From: [Matthew Hebert](#)
To: "[Springbank Community Association](#)"
Cc: [Laura Friend](#); CEAA.Springbank.ACEE@ceaa-acee.gc.ca; ["info@springbankcommunity.com"](mailto:info@springbankcommunity.com)
Subject: SR1 inquiries
Date: December 3, 2019 1:41:06 PM
Attachments: [Responses to Springbank Community Association.pdf](#)

Thank you for your July 26 e-mail to me that brought my attention to your April 1, April 2, and June 5 e-mails regarding the Springbank Community Association's feedback on the Springbank Off-stream Reservoir (SR1 or the Project). Please accept my apologies for the delay in receiving a response. Alberta Transportation remains committed to ongoing engagement with stakeholders as regulatory review of the project continues.

1.0 General	2
2.0 Construction Impacts	3
3.0 Air Quality	4
4.0 Traffic Management	5
5.0 Fish and Wildlife.....	8
6.0 Pipelines	12
7.0 Diversion Channel.....	13
8.0 Design.....	14
9.0 Testing	15
10.0 Project Costs.....	16
11.0 Water Quantity and Quality	19
12.0 Silt.....	25

Figure 4 Historical Temperatures in the Upper Elbow River Mainstem Sites and at Glenmore Reservoir Dam from 1979 to 2016

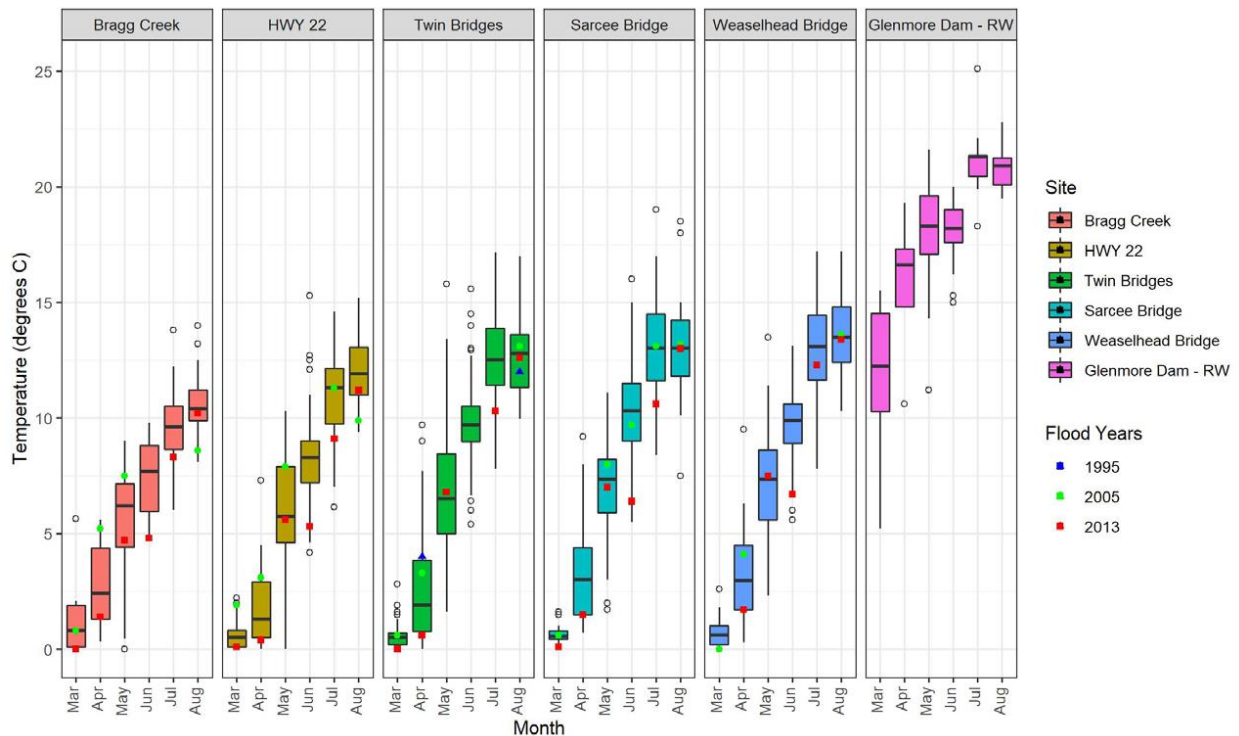
- H. What is the expected contents of the waters being released out of the reservoir and how will the properties of the SR1 water differ from the Elbow River water that bypasses the SR1 footprint?

Historic water temperatures (upper 75th percentiles) in the receiving water (i.e., Elbow River near the PDA at Highway 22) for July and August have been approximately 13°C and 14°C, respectively (see Figure 4 below).

Literature reported water temperatures from upper water column water temperatures in small shallow lakes in Alberta were used as an analog for the off-stream reservoir. Water temperatures in shallow lakes may reach the low 20°Cs during the mid-summer months (Prepas and Mitchell 1990; ALMS 2016, 2017, 2018a, b, c). Historical Glenmore Reservoir water temperatures have reached the low 20°C (see Figure 1 above).
